Planning Commission Agenda

**SUNRISE COMPREHENSIVE PLAN AMENDMENT STAFF REPORT
PROJECT NO. CPA24-001**

FROM: SEAN MCDERMOTT
DATE: 09/06/24
PROJECT: Sunrise Preliminary Plat, Final Plat, Change of Zone, and Comprehensive Plan Amendment
Project No. COZ24-002, CPA24-001, PPL24-001, FPL24-001

Subject: Sunrise Change of Zone, Comp Plan Amendment, Preliminary Plat, and Final Plat (COZ24-002, CPA24-001, PPL24-001, FPL24-001)
Public Works Review

(34' Lot) Front-Load SFD

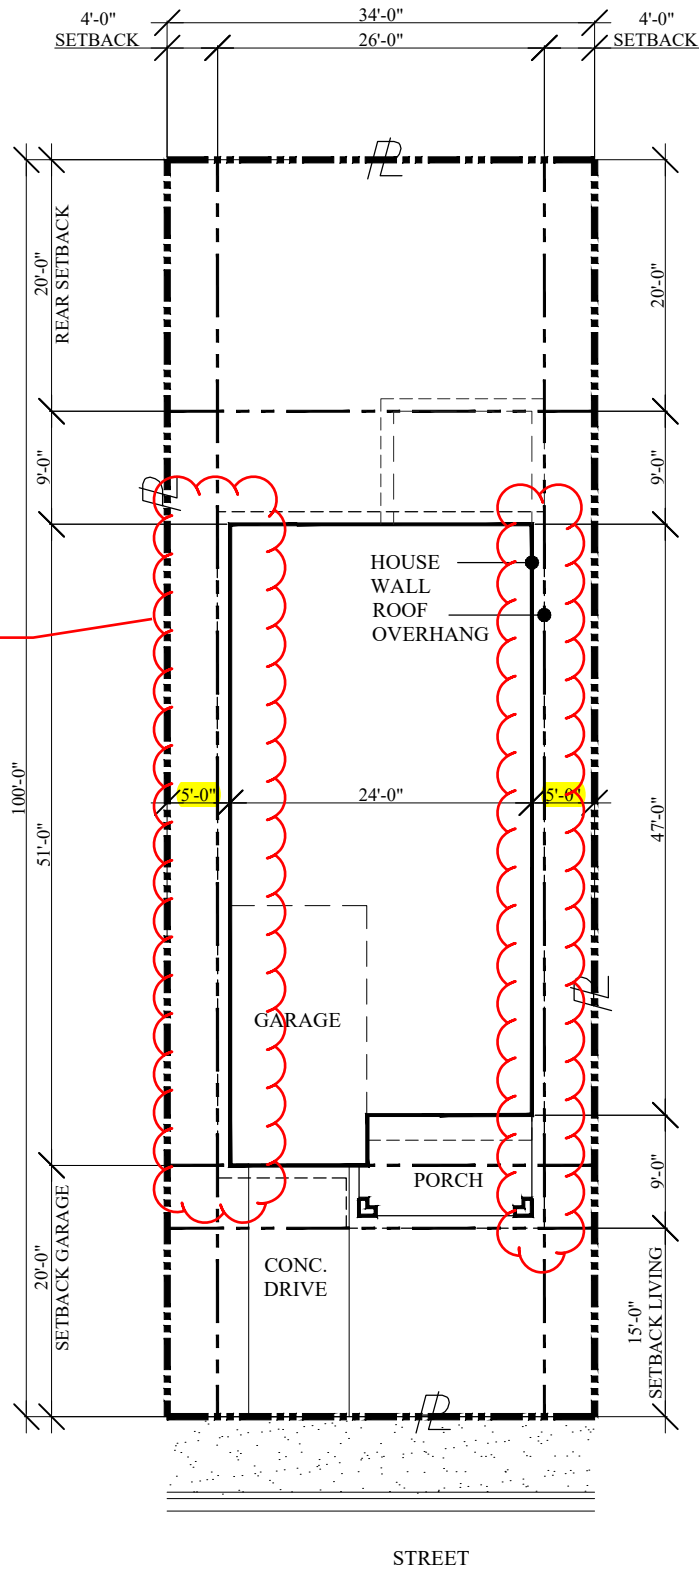
Eaves need to be 1-hr
fire rated

(34' Lot) Front-Load SFD

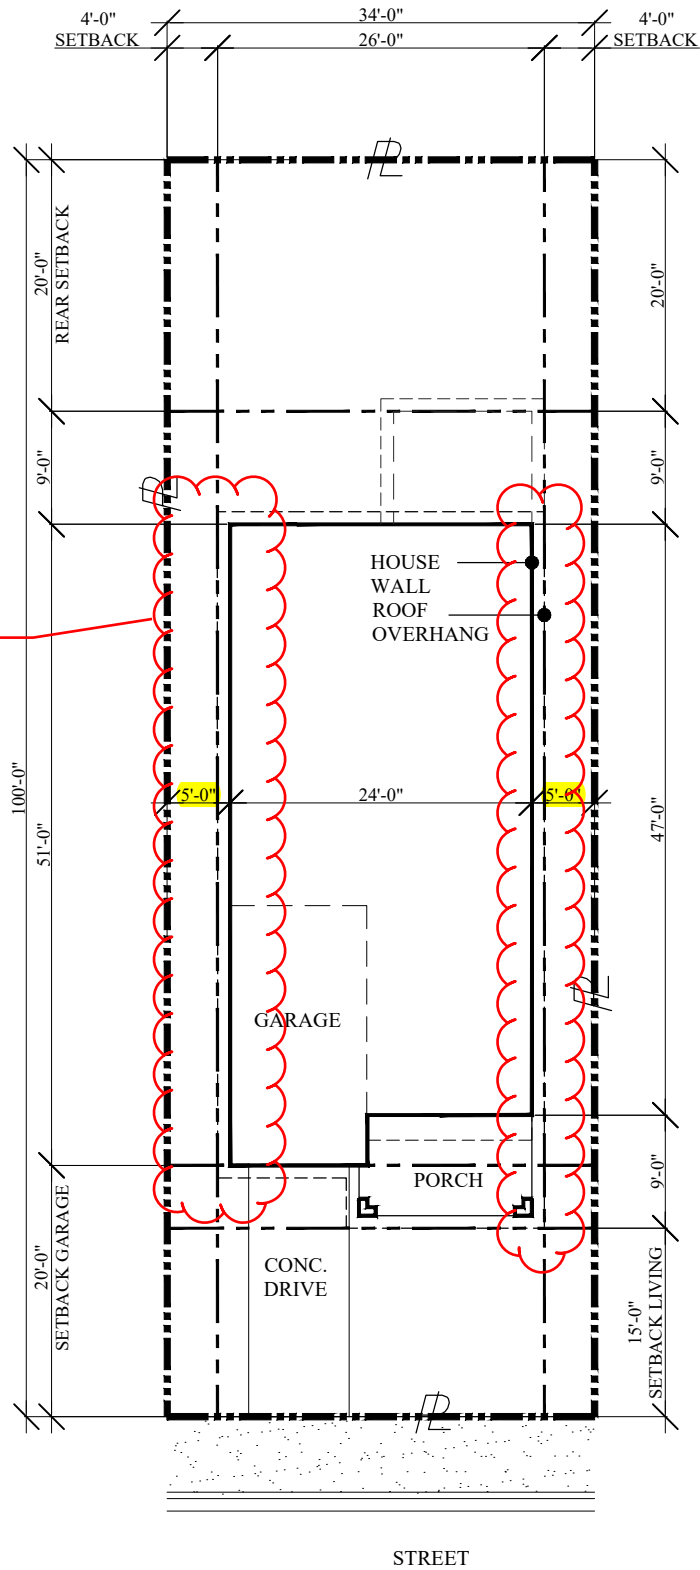
Eaves need to be 1-hr
fire rated

(34' Lot) Front-Load SFD

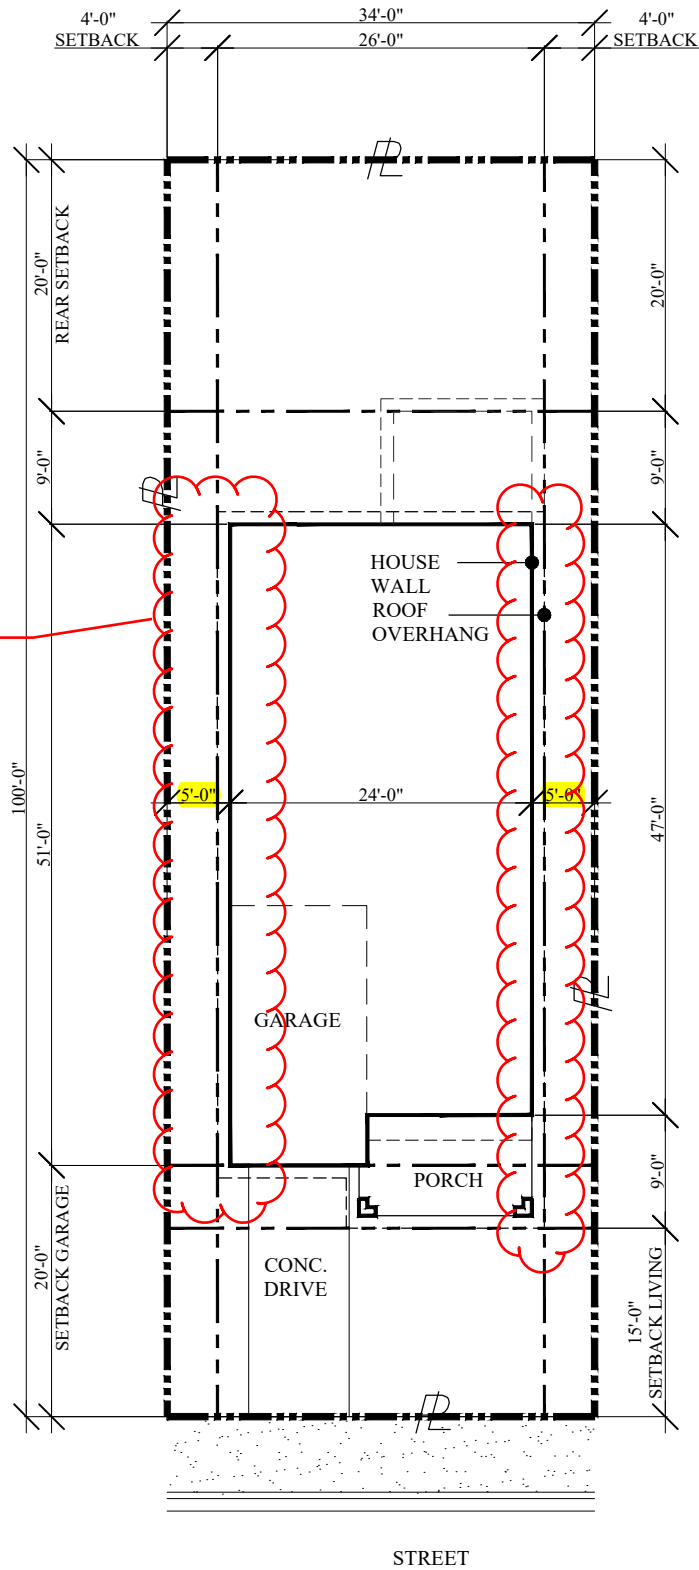
Eaves need to be 1-hr
fire rated
